Subject: IEP NPDES Permit No. WA 000082-5, Draft Permit and Fact Sheet

Please accept this comment letter on behalf of Inland Empire Paper Company (IEP) to Washington State Department of Ecology's (Ecology) Draft NPDES Permit No. WA 000082-5 and Fact Sheet. A complete compilation of comments with references are provided in Attachment "A" for the draft NPDES Permit and Attachment "B" for the Fact Sheet. Note that there are some comments in Attachments "A" & "B" that are not detailed below and will require Ecology response (these are highlighted in yellow in the attachments). The following provides a more detailed explanation of IEP's comments to specific areas of the Permit and Fact Sheet:

**Comment No. 12 – Fact Sheet Reasonable Potential Analysis for Metals**

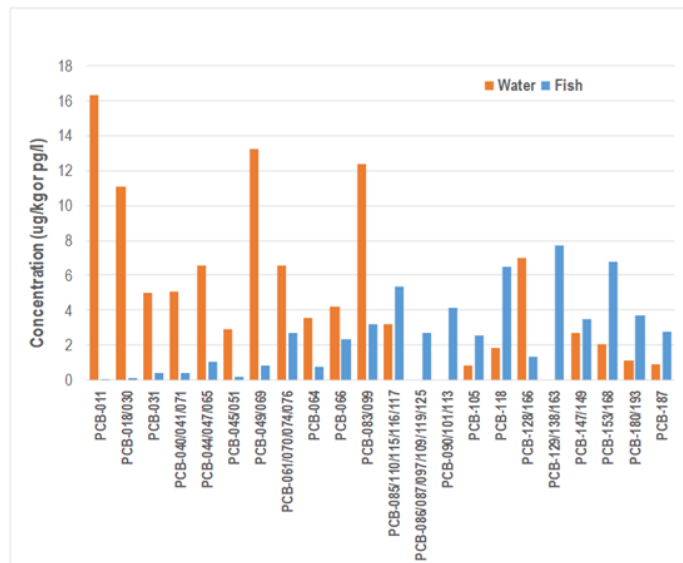
The Reasonable Potential (RP) calculations for Cadmium, Lead & Zinc in the Fact Sheet (Reasonable Potential Spreadsheet – No Mixing Zone; Part 2, page 74) have incorrect values for Effluent Concentrations. The data included in the spreadsheet do not represent currently available metals data and indicate that RP exists based on these inputs. Therefore, this spreadsheet should be revised to reflect actual IEP data that results in no RP for these metals.
